**COMMONWEALTH OF VIRGINIA
STATE CORPORATION COMMISSION**

CASE NO. PUE-2009-00043

For certificates of public convenience
and necessity to construct facilities:
765 kV Transmission Line through
Loudoun, Frederick, and Clarke Counties

DIRECT TESTIMONY

Figure 1
Highlighted lines indicate the areas of alleged 500-kV overloads relevant to PATH.

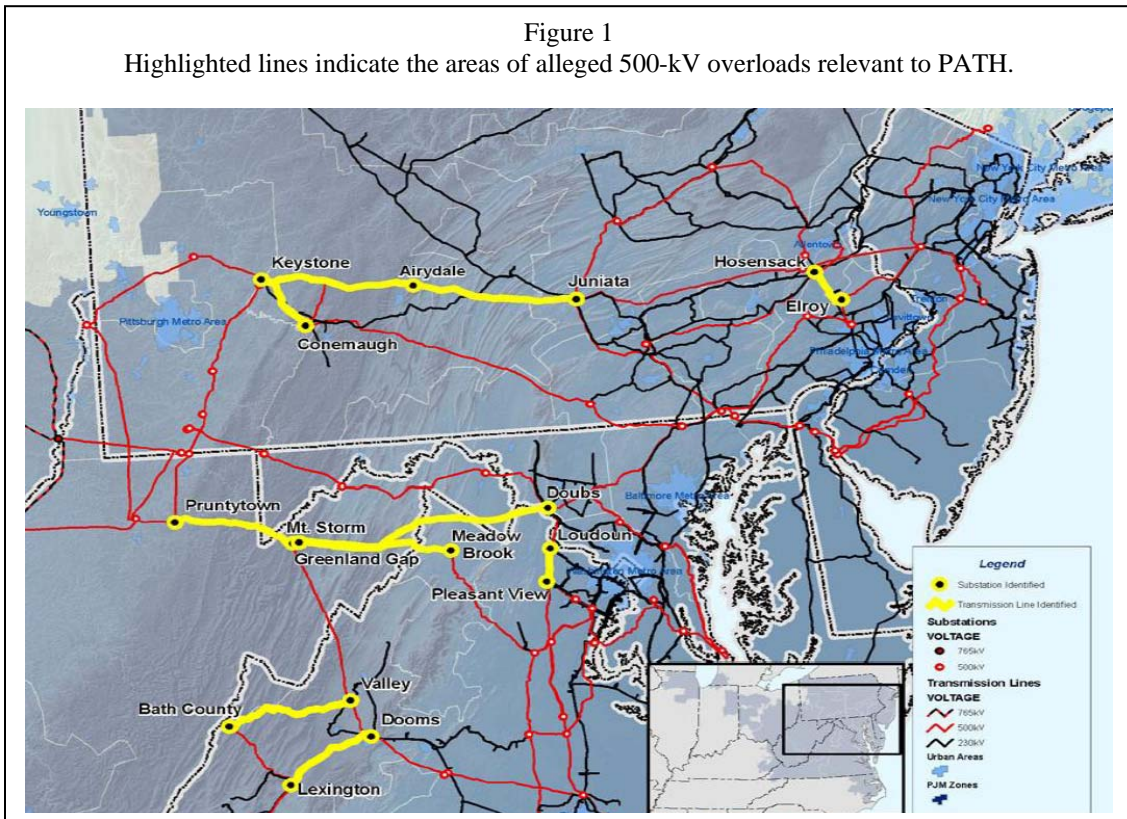
4 A: Figure 1 and Table 3.4, both from the 2007 RTEP, will be helpful in following the
5 discussion below.
